901 NORTH CAPITOL STREET NE ZONING COMMISSION SUBMISSION

PREVIOUSLY APPROVED - ZC CASE NO. 21-09

901 NORTH CAPITOL STREET NE ZONING COMMISSION SUBMISSION : JUNE 16, 2023

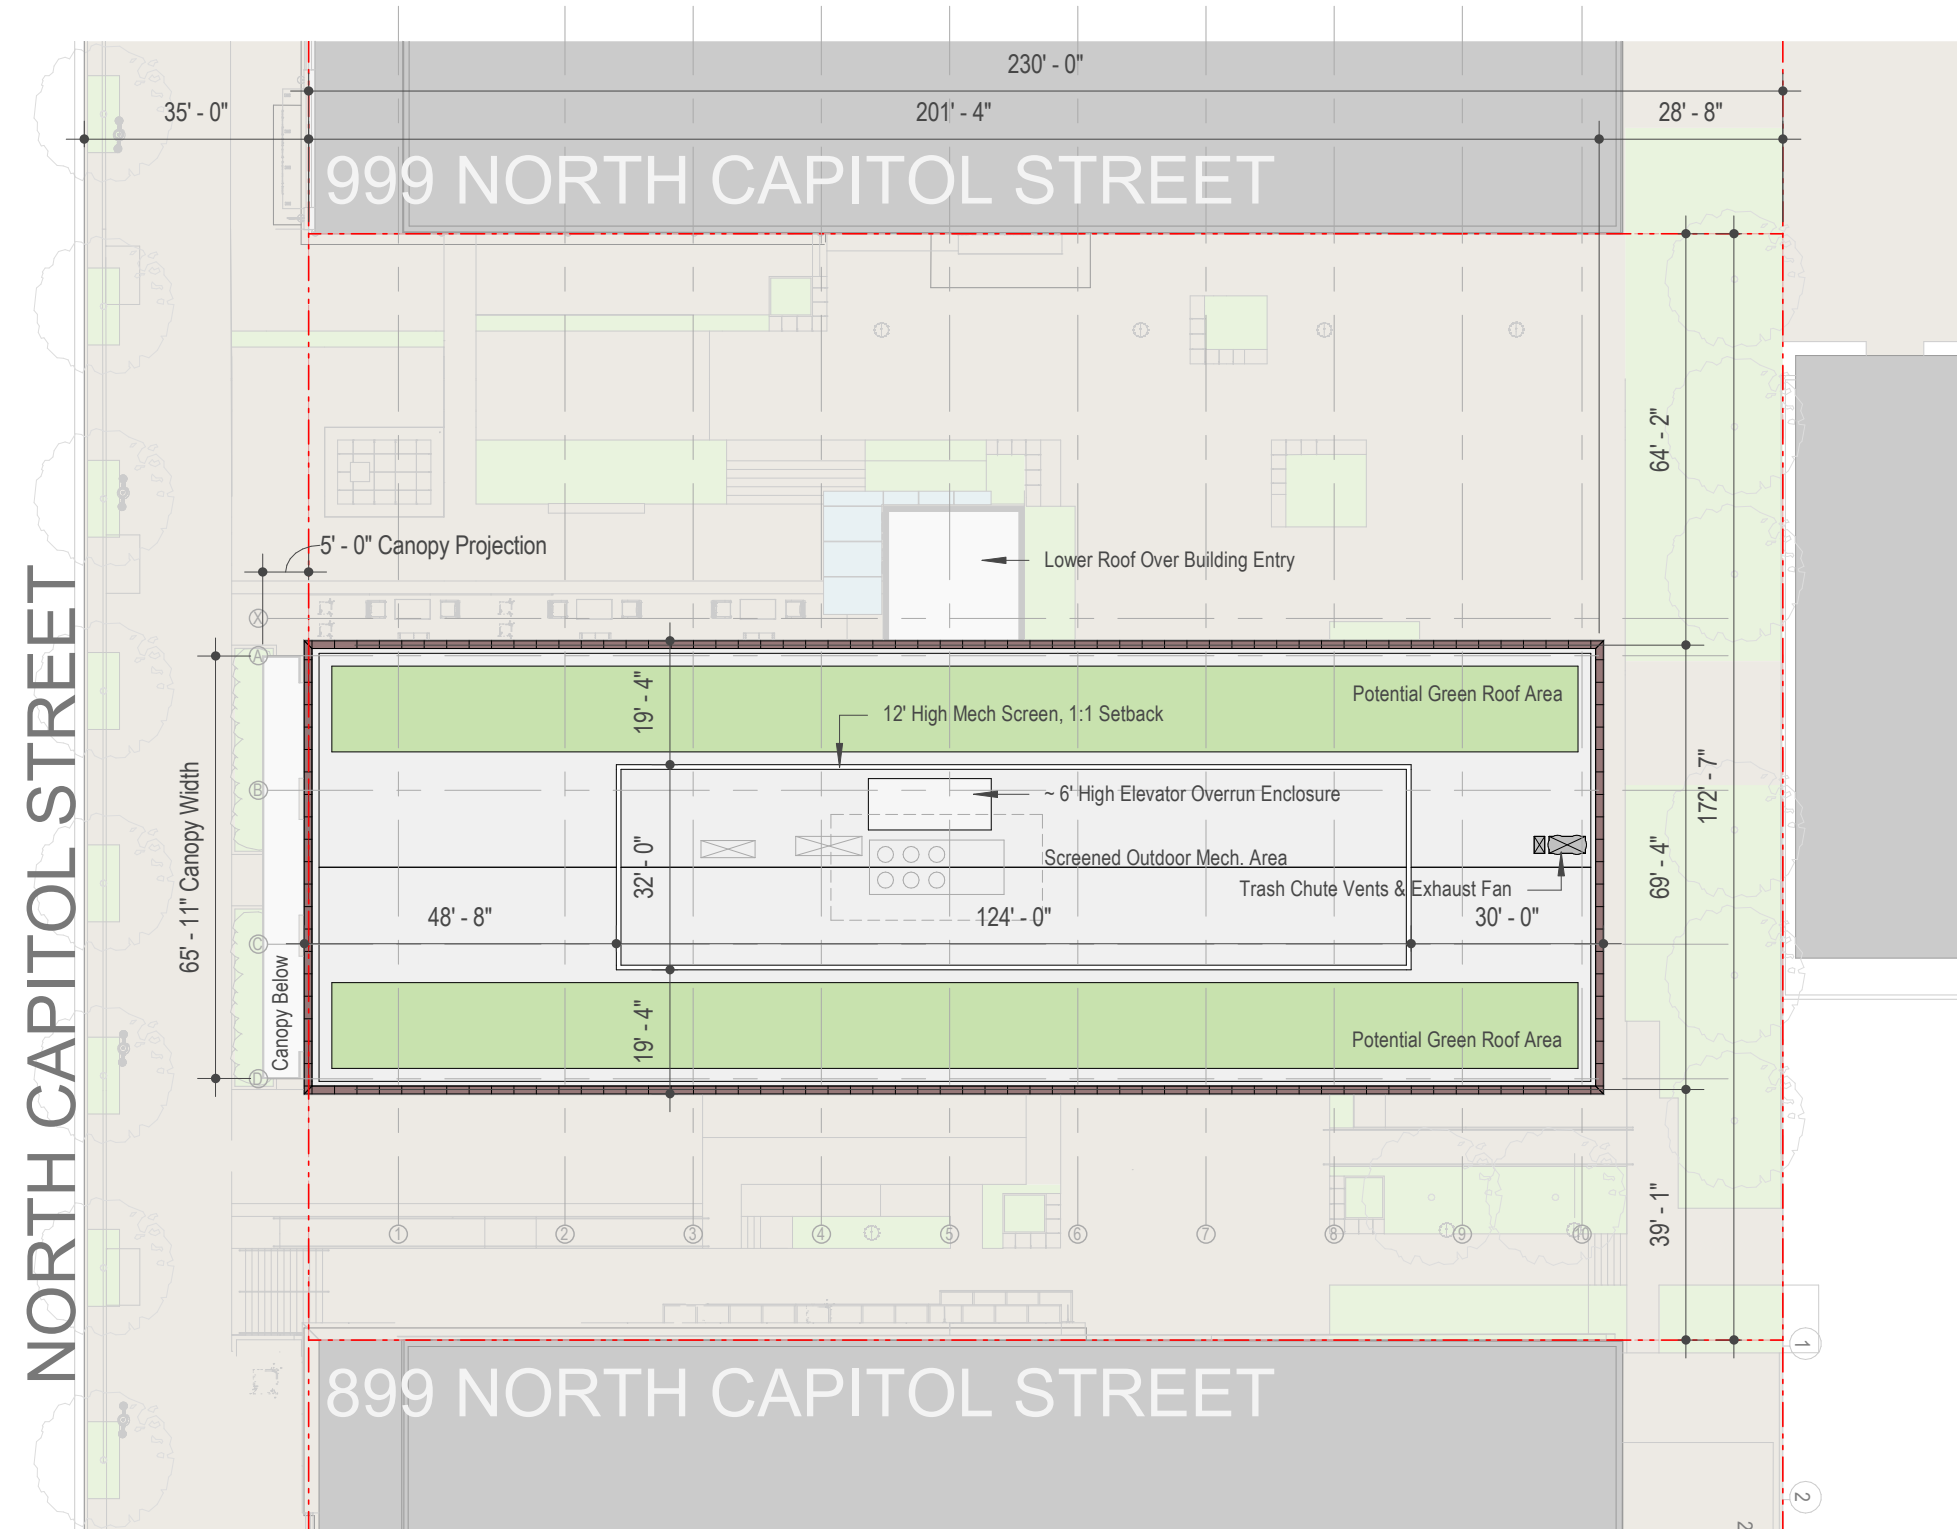
AREA OF MODIFICATION:
FITNESS LOCATION &
UNIT DEMISING
UPDATED

ROOF PLAN : A16 - REV

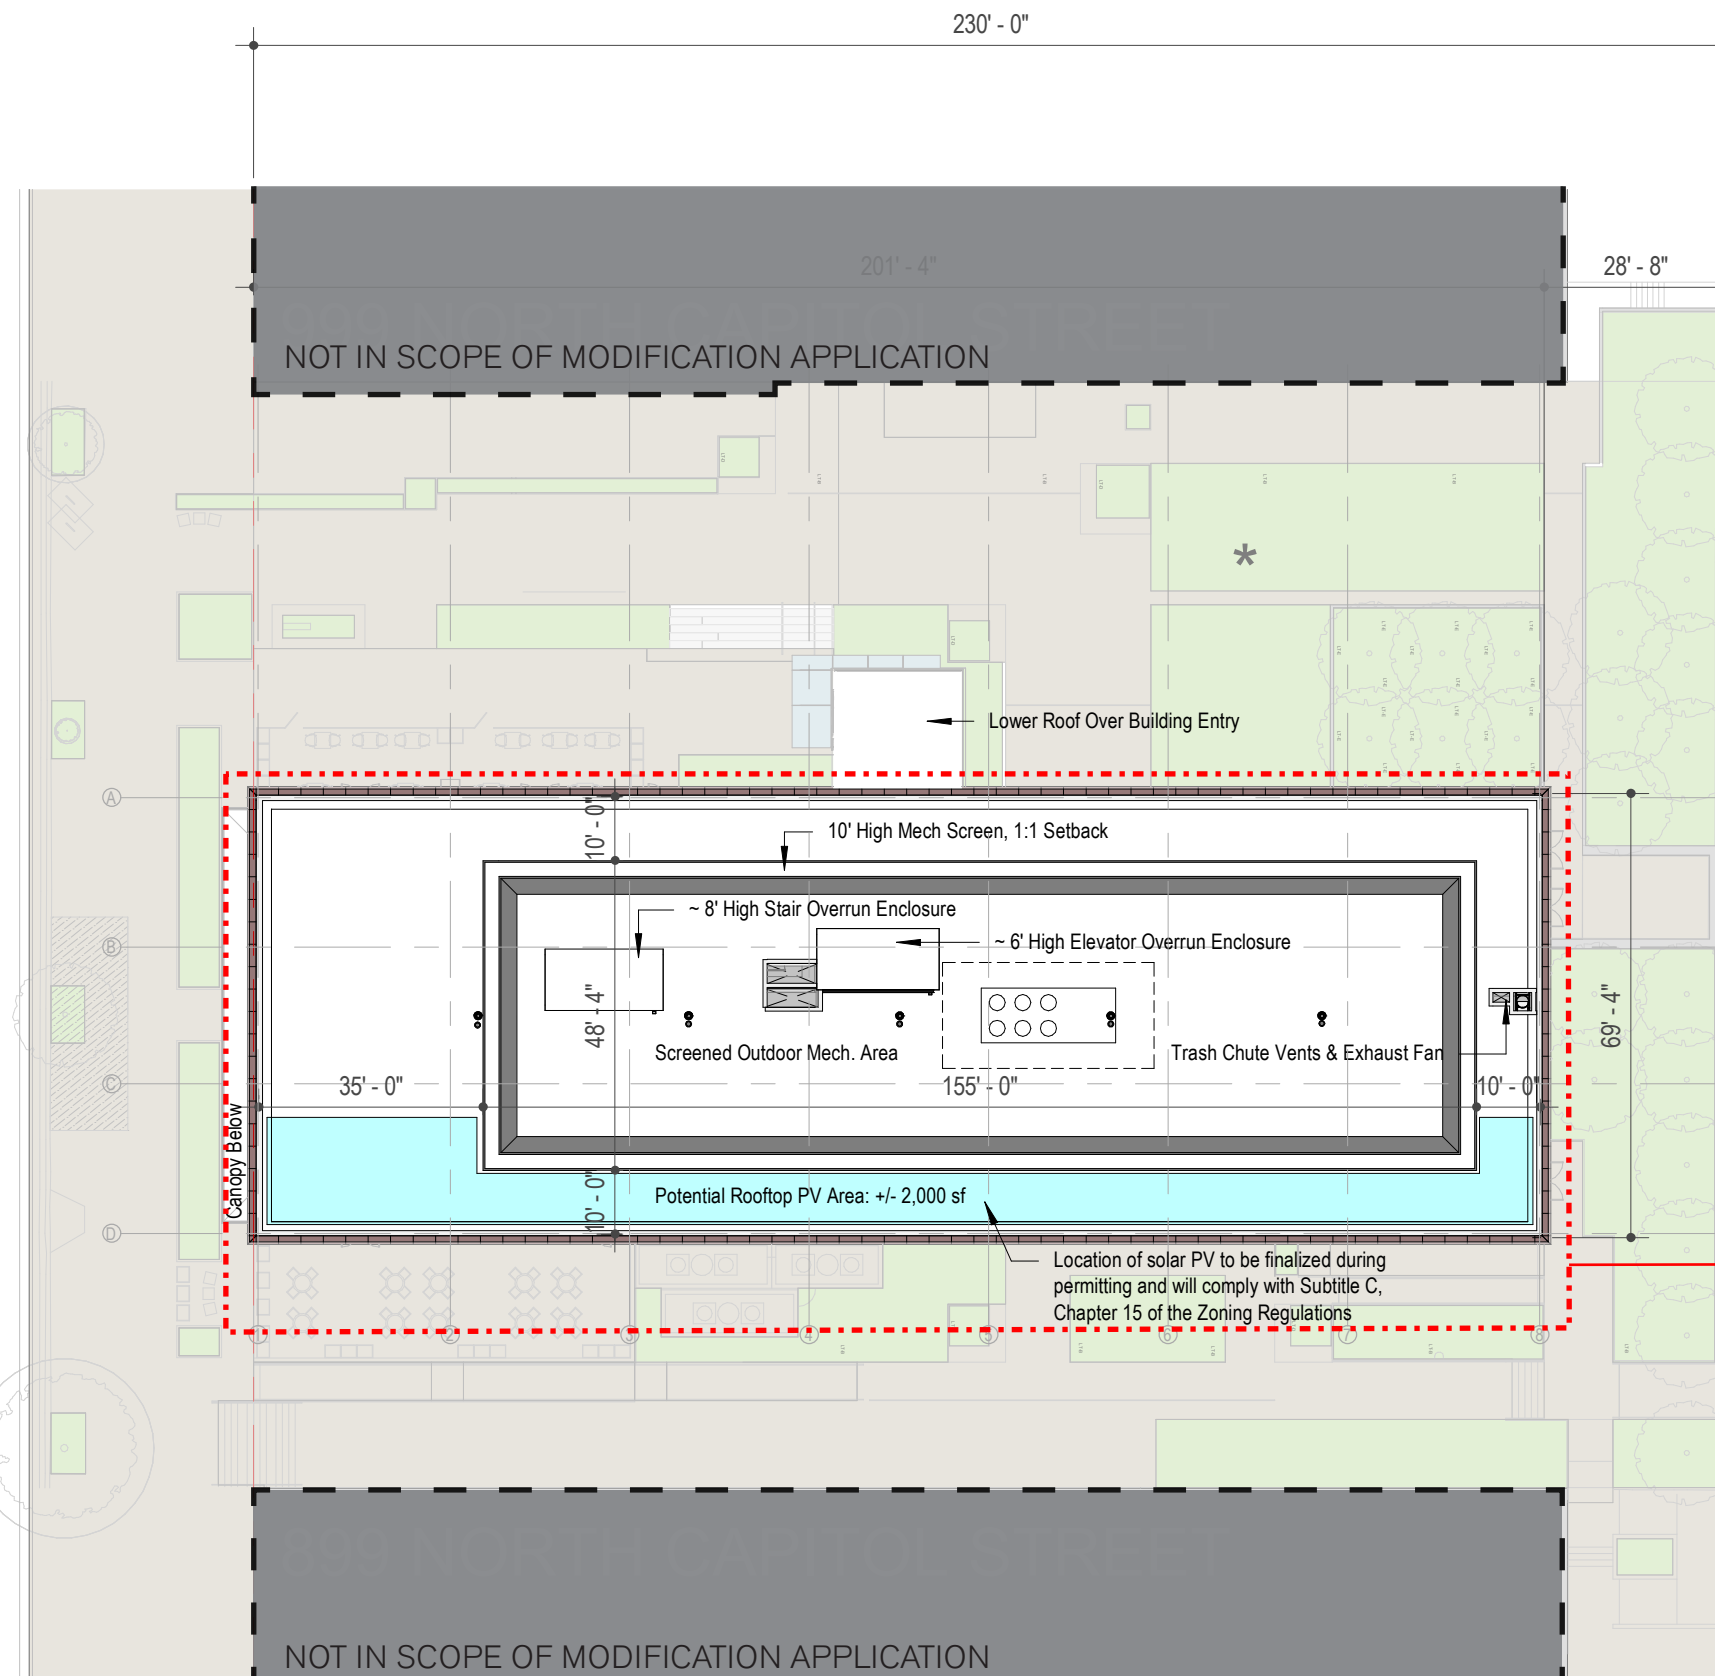
AREA OF MODIFICATION:
MECH. SCREEN UPDATED,
STAIR & ELEVATOR
OVERRUNS UPDATED,
ROOFTOP PV AREA
INTRODUCED, POTENTIAL
GREEN ROOF SQUARE
FOOTAGE TO BE PLACED AT
PLAZA LEVEL.

WEST BUILDING ELEVATION : A17

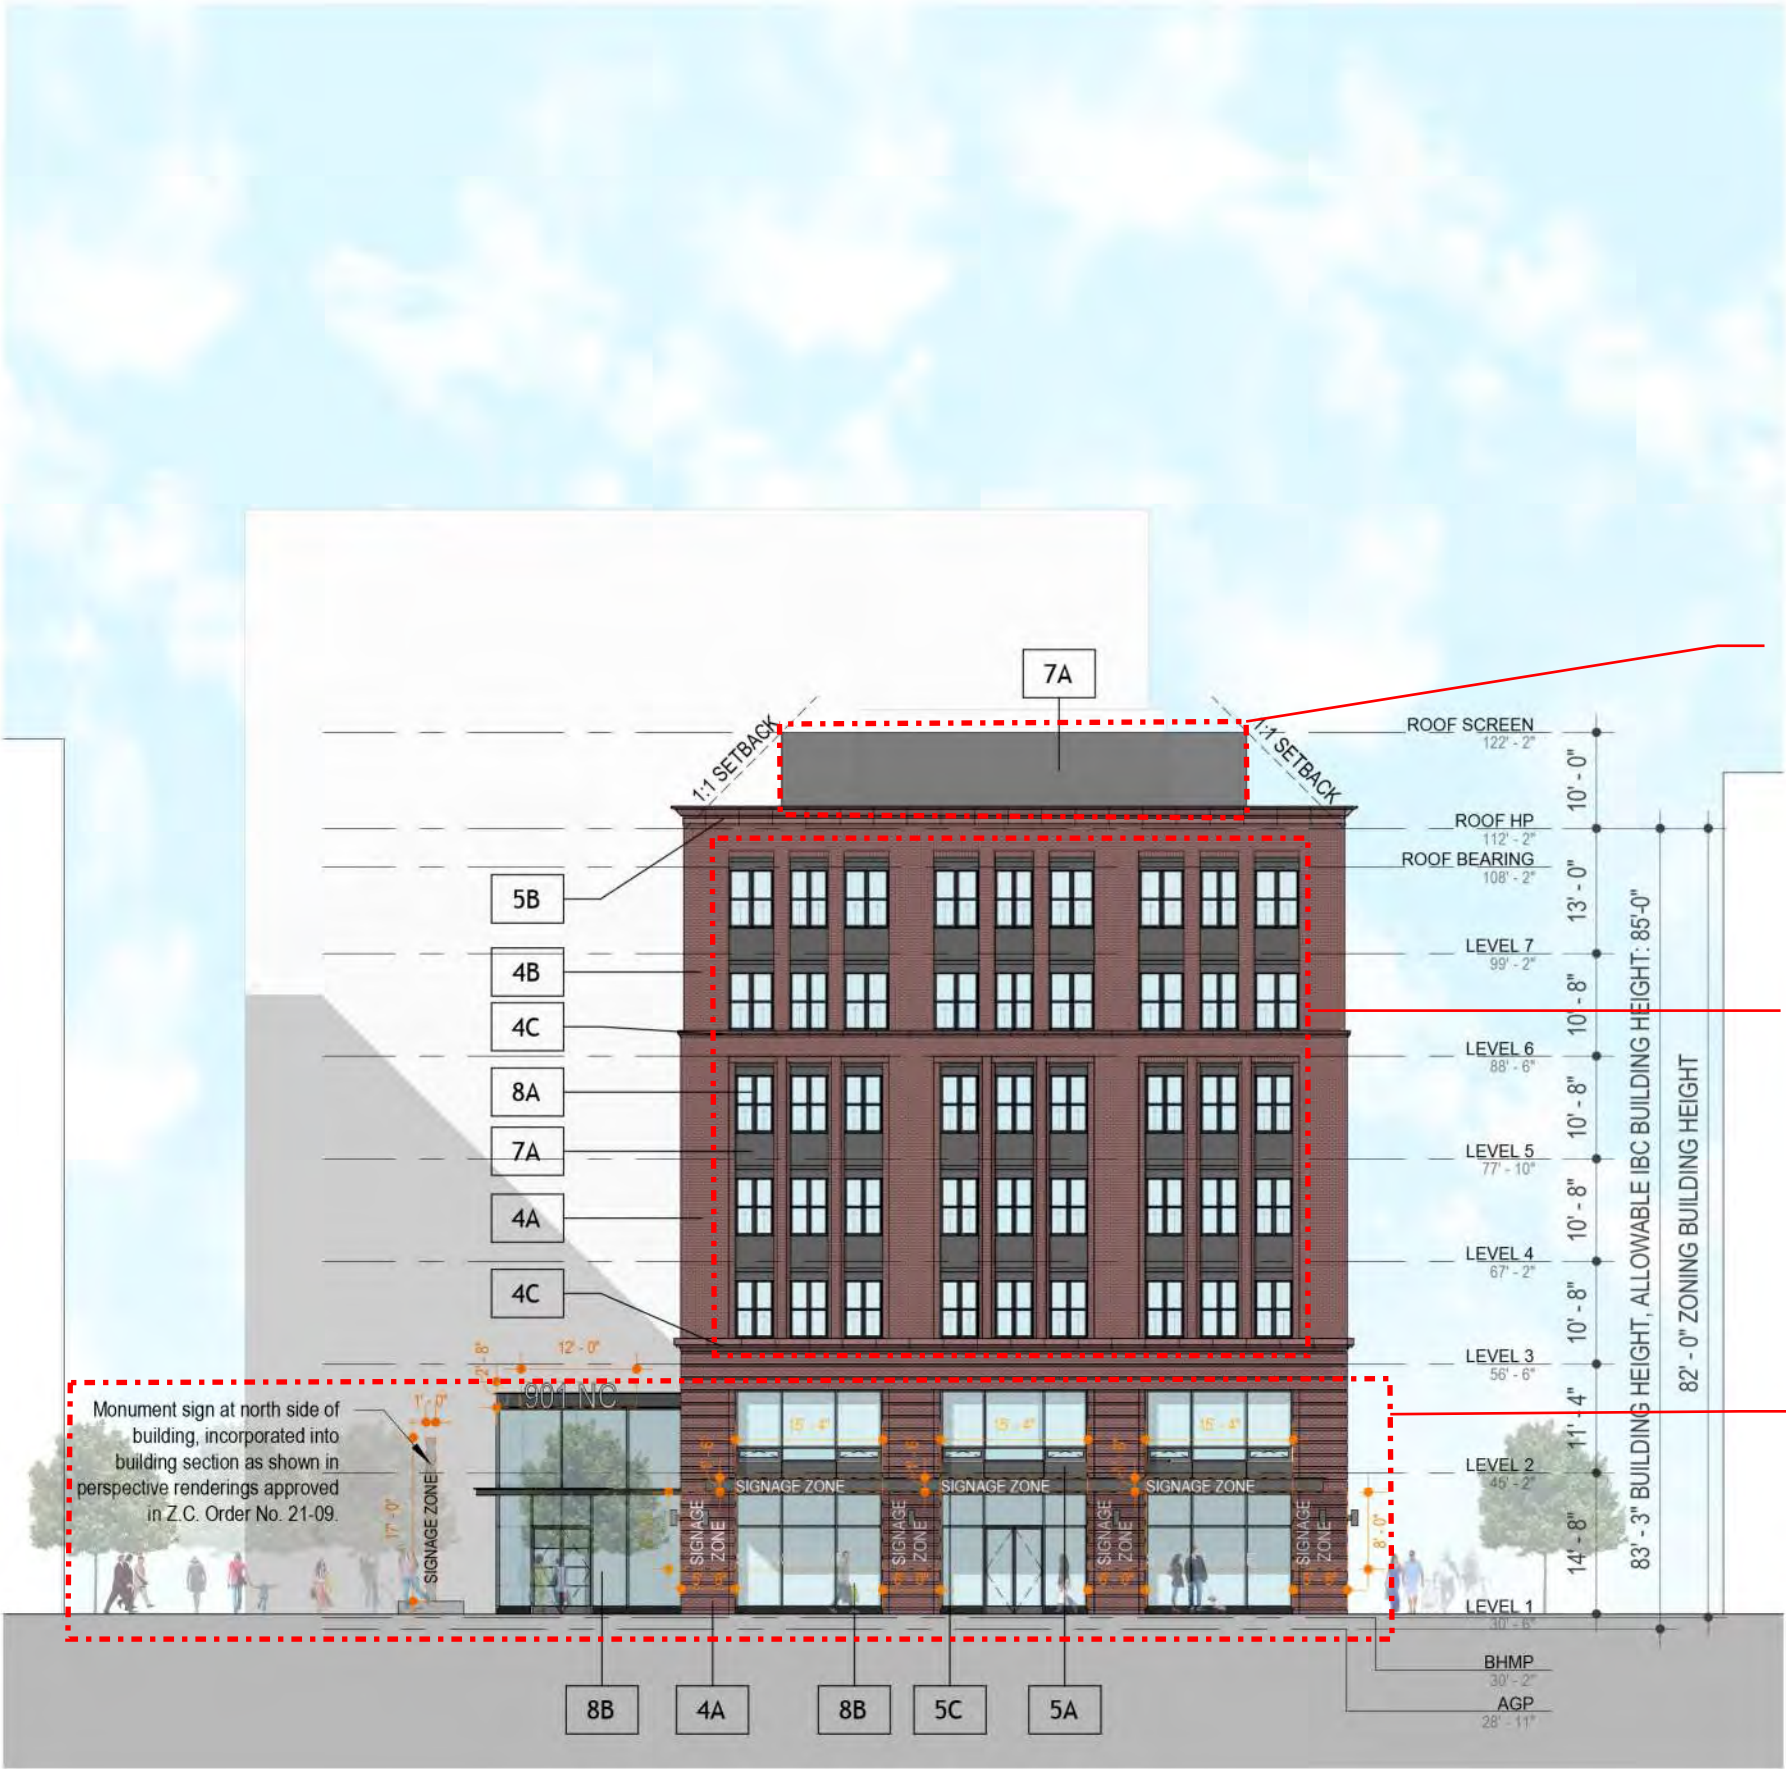
AREA OF MODIFICATION:
MECH SCREEN UPDATED

AREA OF MODIFICATION:
WINDOWS UPDATED: TWO SIDE BY
SIDE SINGLE HUNG WINDOWS, TYP.

AREA OF MODIFICATION:
SIGNAGE ZONES UPDATED,
LEVEL 2 STOREFRONT
UPDATED: FIXED WITH LOWER
OPERABLE WINDOWS, TYP.
